# UNITED STATES PATENT AND TRADEMARK OFFICE

APPLICATION NO.	FILING DATE	FIRST NAMED INVENTOR	ATTORNEY DOCKET NO.	CONFIRMATION NO.
10/755,427	01/12/2004	Lee Bolduc	203-2626 DIV CON VIII (24)	9695
7590 Mark Farber, Esq. U.S. Surgical, A Division of Tyco Healthcare Group, LP 150 Glover Avenue Norwalk, CT 06856			EXAMINER YABUT, DIANE D	
			ART UNIT 3734	PAPER NUMBER
			MAIL DATE 04/10/2009	DELIVERY MODE PAPER

<b>Office Action Summary</b>	<b>Application No.</b> 10/755,427	<b>Applicant(s)</b> BOLDUC ET AL.	
	<b>Examiner</b> DIANE YABUT	<b>Art Unit</b> 3734

### DETAILED ACTION

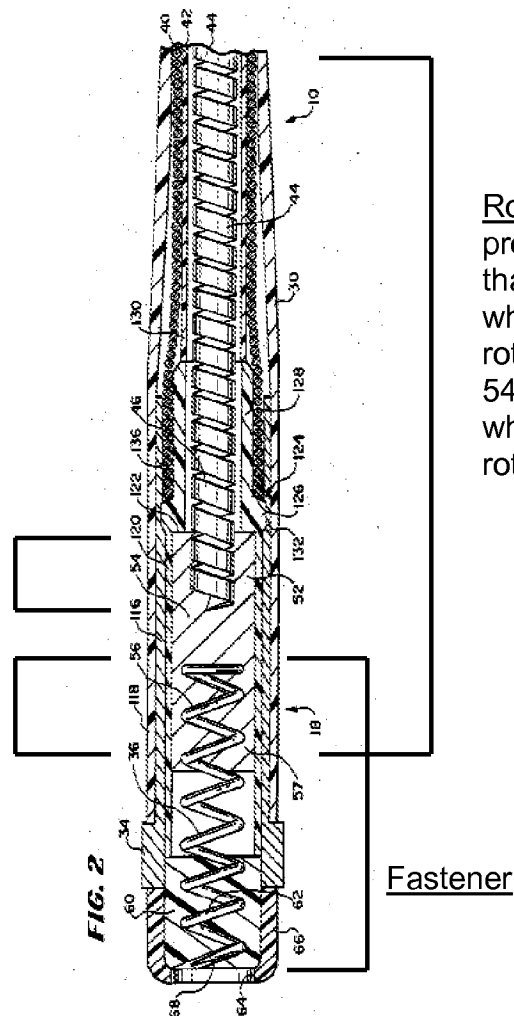
Claims 1, 4-6 and 19: Miller discloses an applicator comprising a distal portion having an elongate outer tube **30**, a connecting end and a terminal end, a proximal portion having a handle and an actuator **22**, the proximal portion being attached to the connecting end of the distal portion, and a rotator **44** cooperating with the actuator, the rotator including a longitudinal groove extending along at least a portion thereof (within the distal end **54** of rotator), the groove configured to receive a portion of a fastener **36**, wherein the rotator resides within and extends substantially the length of the outer tube such that actuation of the actuator rotates and translates the fastener relative to the outer tube while the rotator remains longitudinally or axially stationary with respect to the outer tube (Figures 1-3; col. 5, line 57 to col. 6, line 22). The applicator has a thread form **62** contained in an interior of the terminal end adapted to engage a plurality of fasteners and being an interlock spring fixedly retained in the interior of the terminal

end, wherein "spring" is taken to mean an "actuating force." This may also be considered as a nose piece **60** that has structures projecting perpendicularly toward a longitudinal axis of the outer tube and adapted to engage a plurality of fasteners. The proximal and distal portions

Longitudinal grooves are within distal end 54 of rotator which engage with the proximal end 44 of rotator and proximal end of fastener 62

Rotator has a proximal end 44 that is rotated, which in turn rotates a distal end 54 of the rotator, which ultimately rotates fastener 62

9. The applicant generally argues that Miller fails to disclose the rotator having a longitudinal groove extending along at least a portion thereof. The examiner disagrees. The examiner mentioned that the longitudinal groove is within a distal end **54** of the rotator, which rotates along with a proximal end **44** of the rotator, and holds the proximal end of a helical fastener **62**, as clarified in the annotated figure 2 above. In order to be mounted onto the distal end **54**, there must be a groove that accepts the fastener **62**, which is suggested in figure 2.
